# EXHIBIT E

#### ACCEPTANCE NOTICE FOR THE EXPANSION OF CENTRAL MAUI SANITARY LANDFILL PROJECT FINAL ENVIRONMENTAL IMPACT STATEMENT

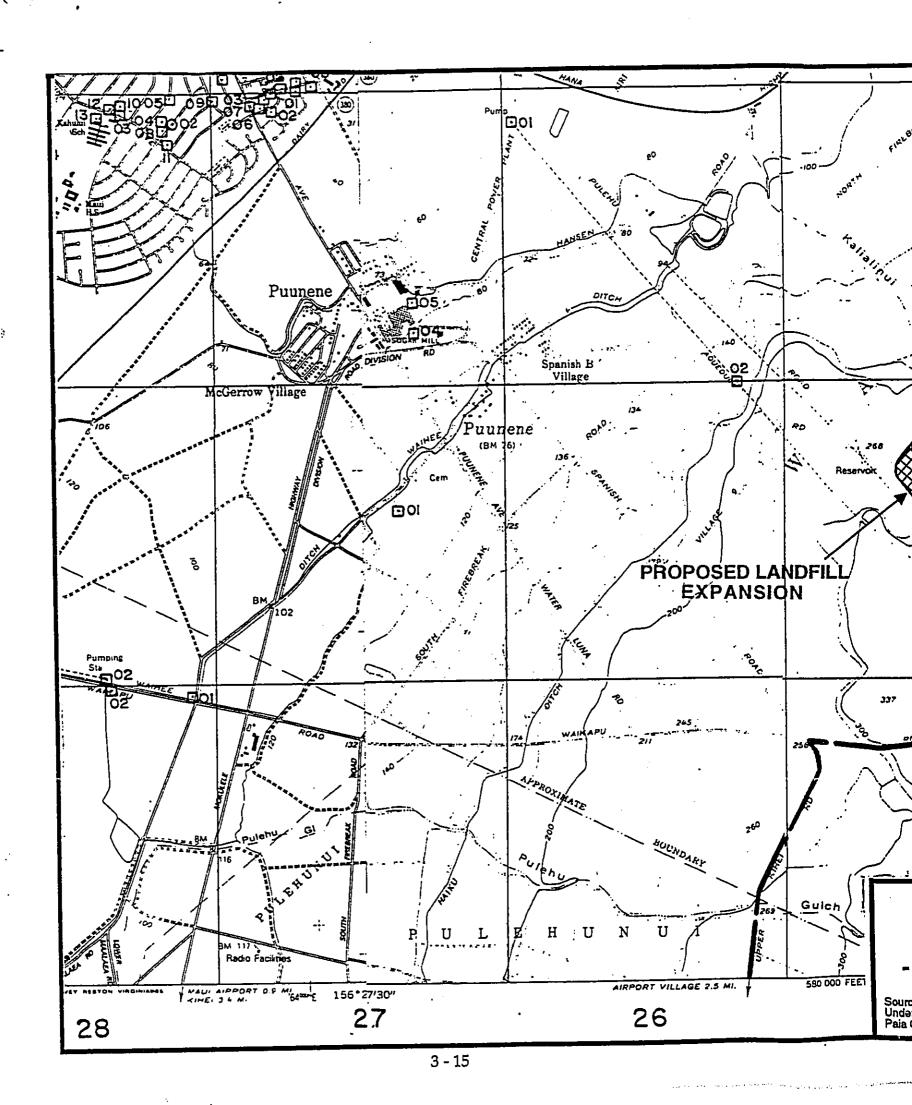
Section.3.2.8 Groundwater Resources.- We have revised Figure 3-5 and Table 3-2 include all the wells within 2 miles of the site. Thank you for providing information on the HC&S irrigation wells.

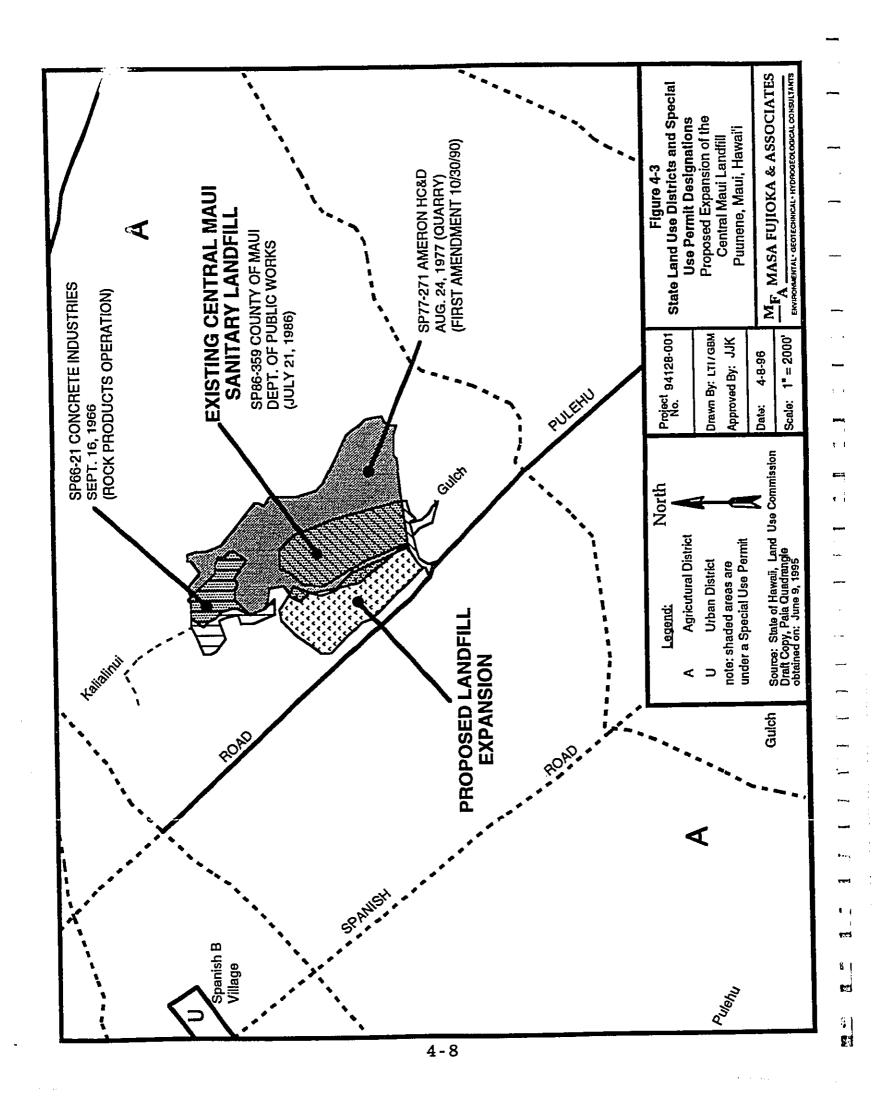
Thank you for confirming that the proposed project site is located within the State Land Use Agricultural District. We will make the necessary corrections to the Special Permit dates shown in Figure 4-3 of the draft EIS.

- Ameron's Special Permit SP77-271 covers a small portion of Phases IV, V, and VI adjacent to the Kalialinui Gulch. Section 4.3.2 of the EIS and Figure 4-3 will be corrected to reflect this. ત
- We will correct section 11.0 of the EIS to indicate that your office will render a final decision on the Permit only if the Maui Planning Commission recommends approval of the Permit. က
